Submission of Further Information (FI)

Temporary Warehouse (Excluding Dangerous Goods Godown) with Ancillary Office and Public Utility Installation (Solar Photovoltaic System) and Associated Filling of Land for a Period of 3 Years in "Agriculture" Zone, Lot 177 (Part) in D.D. 110, Kam Tin North, Yuen Long (Application No. A/YL-KTN/1294)

Further Information for Planning Application No. A/YL-KTN/1294

1:500	**Layout Plan**	Goldrich Planners & Surveyors Ltd.
November 2026	Lot 177(Part) in DD.110	Plan 3a (P 26054)

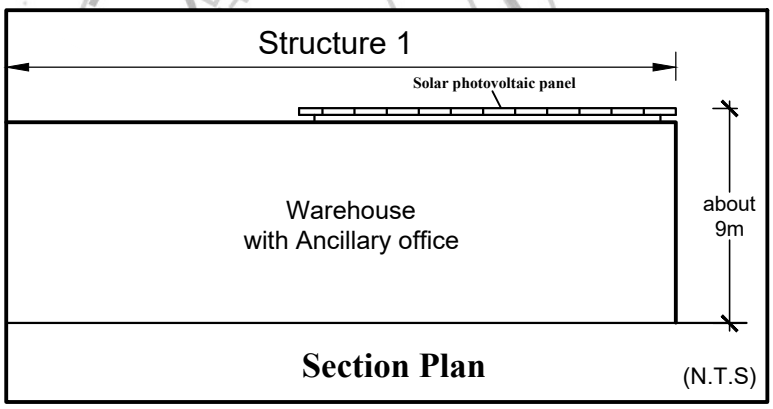
2.	Please provide the details of the solar panel system including but not limited to its dimension (including its height), the location(s) of the utility/electricity meter/distribution board/inverter and materials;		The dimensions of the solar panel, including the height of the metal mounting frame on the rooftop are about 1,060mm (W) x 1,760mm (L) x 90mm(H) each. The utility/electricity meter/distribution board/inverter and materials are installed on internal wall of structure 1. Please see the updated layout plan (Plan 3a) for details.

4.	Please provide the section plan for structure 1.		Please see the updated layout plan (Plan 3a) for the section plan.
